From: [REDACTED]
Sent: 7/11/2024 9:28:05 AM
To: Council Northernbeaches Mailbox
Cc: Ted Campbell; VC; Adam Rytenskild; Brendon Barry
Subject: TRIMMED: OBJECTION: DA 2023/1289: 1112 - 1116 BARRENJOEY ROAD
PALM BEACH NSW 2108; NSWLEC
Attachments: 1112 AMENDED PLAN SUBMISSION.pdf;

PROPOSAL: CONSTRUCTION OF A SHOP TOP HOUSING AT 1112-1116 BARRENJOEY
ROAD, PALM BEACH

SUBMISSION

LAND & ENVIRONMENT COURT PROCEEDINGS NO. 2023/00465007
PROPERTY: 1112 - 1116 BARRENJOEY ROAD PALM BEACH NSW 2108
APPLICANT: PALMDEV PTY LTD
RESPONDENT: NORTHERN BEACHES COUNCIL
PROPOSAL: CONSTRUCTION OF A SHOP TOP HOUSING AT 1112-1116 BARRENJOEY
ROAD, PALM BEACH
DA 2023/1289

2 AMENDED BUILT FORM ENVELOPE 01

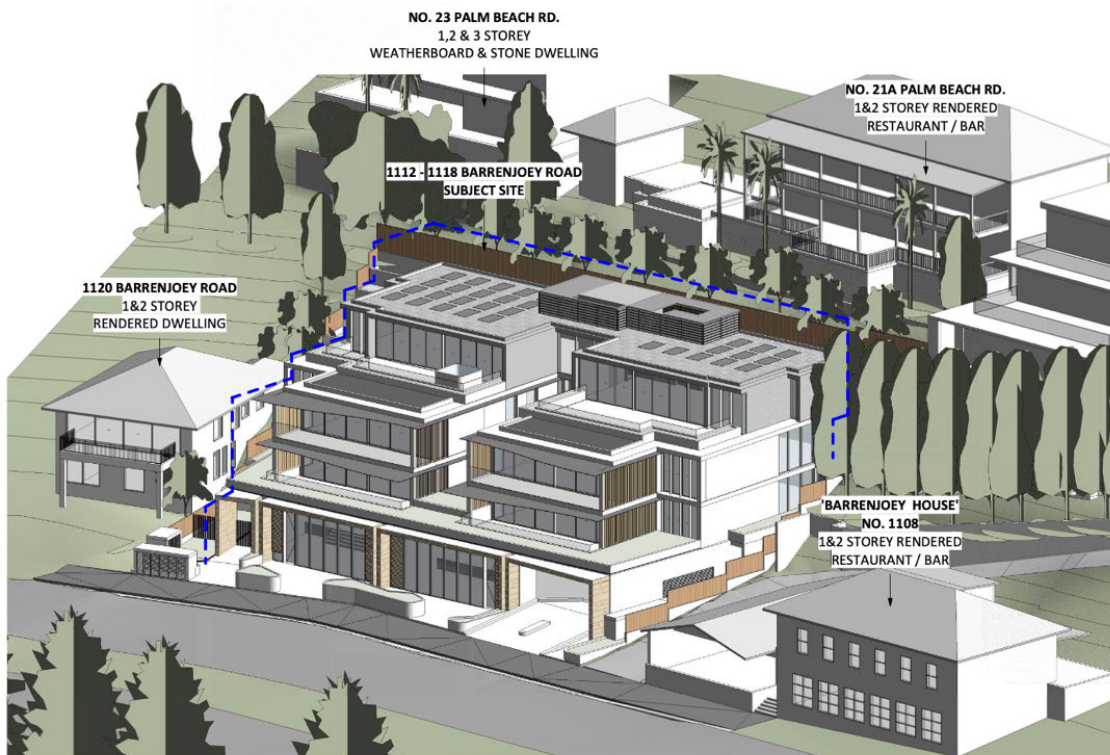
[note: #21 Palm Beach Road incorrectly labelled as 1 & 2 Storey Restaurant/Bar - should read 2-Storey Dwelling]

- **NO BUILT FORM BEYOND 8.5m HOB**
- SECOND FLOOR to be recessed by 17m from the front boundary, to accord with 8.5m HOB standards and 6m from side boundaries so as not to be substantially seen from the public domain, with roof at RL 12.75m, not to exceed RL 4.25 contour as presented by the EGL along the side boundaries
- THIRD FLOOR delete
- ROOF PLANT to be at a maximum height of RL 13.25

Figure 1 – Building height blanket diagram showing the location and extent of building elements located above the 8.5 metre building height standard calculated in accordance with Merman

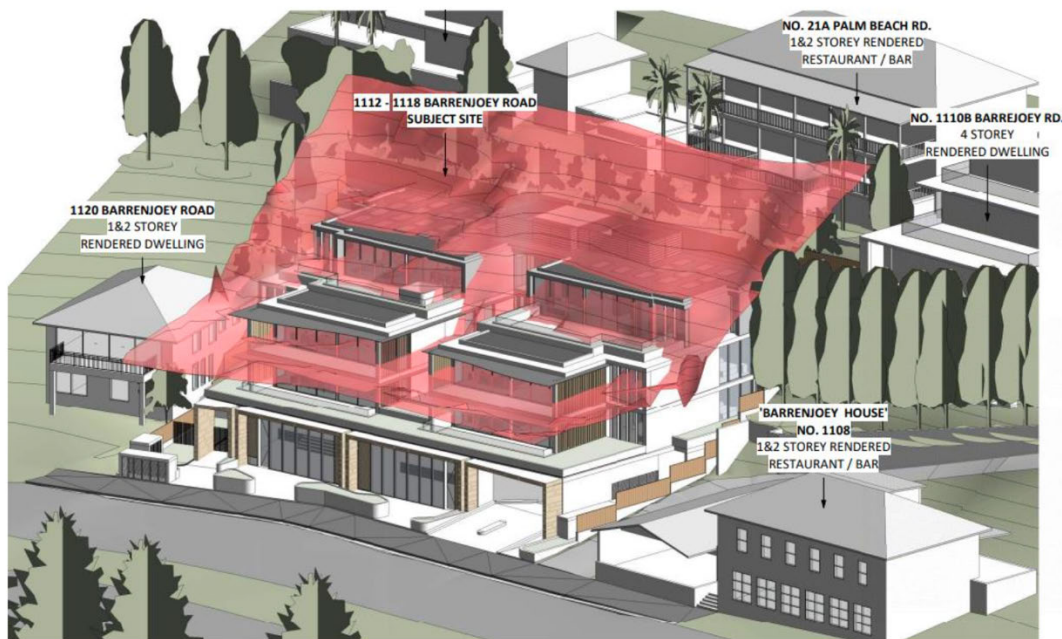
[note: #21 Palm Beach Road incorrectly labelled as 1 & 2 Storey Restaurant/Bar - should read 2-Storey Dwelling]

Figure 1 from the Clause 4.6 shows the substantial non-compliances to the 8.5m HOB standard. A compliant built form requires the proposed Second Floor to be substantially setback from the front boundary, as the non-compliance runs some 17m deep into the site at this level. The Third Floor equally has further non-compliance, and my clients asks for the deletion of this level, due to HOB non-compliance and to the inappropriate massing adjacent Barrenjoey House and the neighbour at #1120. The character of the area does not present built form to four levels on either site at #1108 Barrenjoey House or #1120.

2 AMENDED BUILT FORM ENVELOPE 01

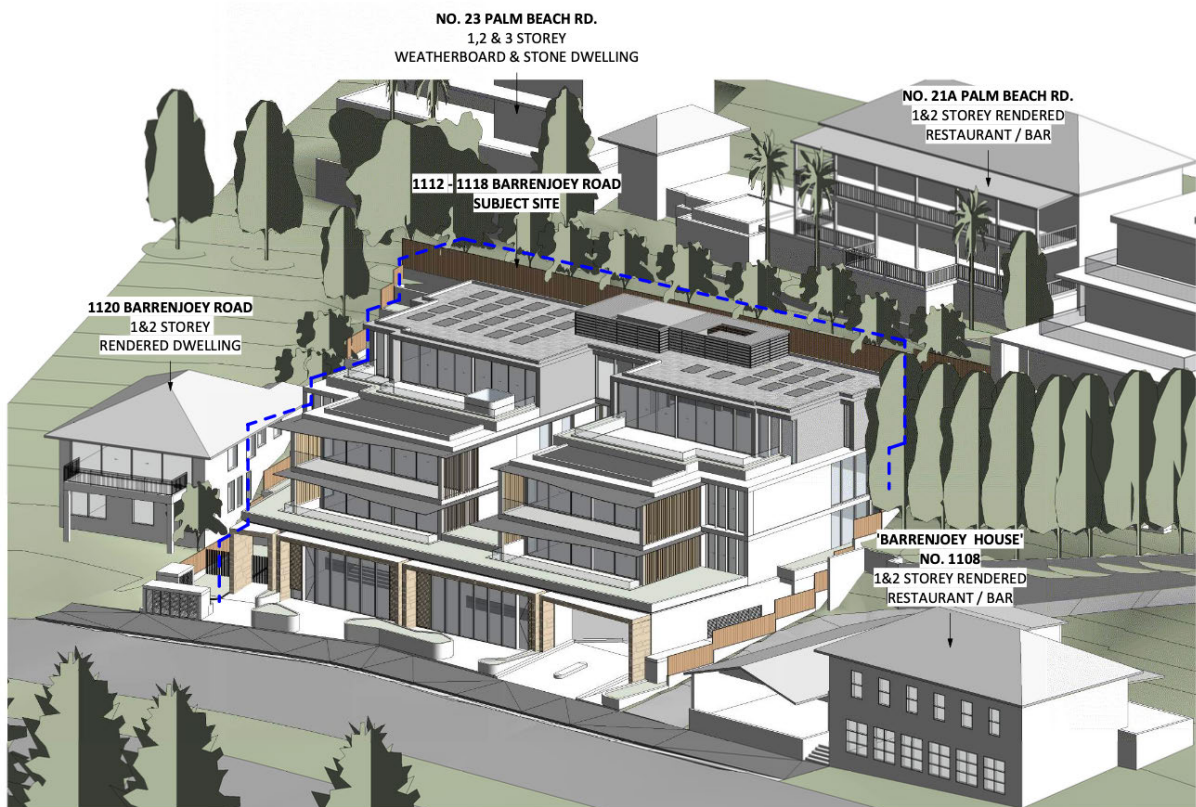
[note: #21 Palm Beach Road incorrectly labelled as 1 & 2 Storey Restaurant/Bar - should read 2-Storey Dwelling]

The proposed development does not respond to or complement adjoining heritage, does not respond to the topography of the site and is not in keeping with the unique character of the locality.

View with 3D model of proposed 1112-1116 Barrenjoey Rd overlaid as 50% transparency
View from 21A Palm Beach Rd, Palm Beach main living deck area
 Objection to 1112-1116 Barrenjoey Rd, Palm Beach-DA2023/1289

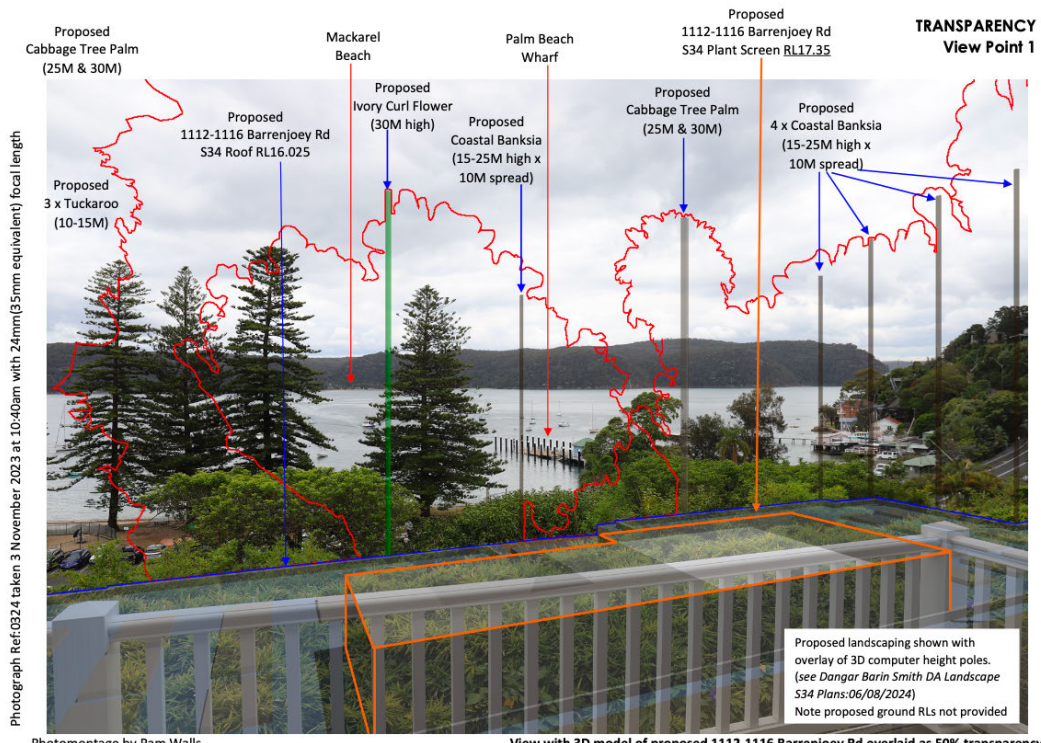
My clients are concerned that new trees are positioned within the Tenacity Viewing Corridors to my clients' view, and those new trees are unreasonable as they will severely affect my client's view.

There are over 60 proposed trees over 10m in height and concern is expressed that the applicant's view impact montages have not assessed the view loss impact from the proposed canopy. The applicant's original set of montages were incorrect, and therefore we have no confidence as to the accuracy of what has been presented within this set of amended plans.

My client has instructed Pam Walls to update the view impact montages. I attach those montages that clearly show a severe view loss caused from potential excessive canopy.

The montages also show the concerns on the location of the AC Units, and Solar Panel issues:

- AC Units be to located away from the roof, and into zones away from highly used zones of my client's property.
- All Solar Panels and PV systems are to be treated with antireflective glass. Solar glass is to be stippled and light-trapping, with photon-absorbent solar cell attached to the rear side. Angle of reflectivity to neighbours must be considered within final detailed design at construction certificate stage, considering the view from neighbours from above the subject site.

- To maintain view sharing, the proposed trees and plants **over 8.5m in height** shall be deleted in the landscape plan and replaced with trees less than 8m in height. Tree planting shall be located to minimise impacts on view loss, with no trees or landscape species removing water views
